We are changing the weather gasket provided with the Surface Mount Housings used on the 26SA, 28SA-Plus and the SK028-040 series Touchcard® readers. An external gasket will be provided in place of the embedded gaskets we have previously used.

SECURA KEY

DATE: 3/22/01
REV.:
AF#: 5314

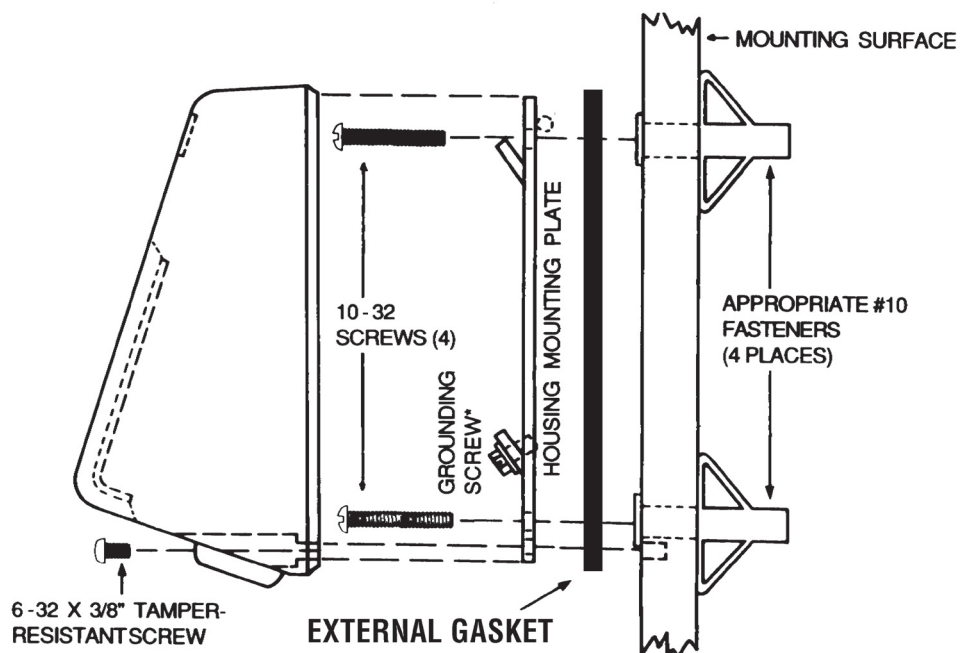
The new external gasket will be similar to the high density foam rubber gasket that we have always used with our more expensive surface metal housings. The new gasket will provide superior protection, especially on irregular mounting surfaces.

The new gasket should be placed between the reader mounting plate and the mounting surface. If you are replacing an older reader with a new one, you will need to remove the mounting plate and install the new gasket before attaching the new reader.
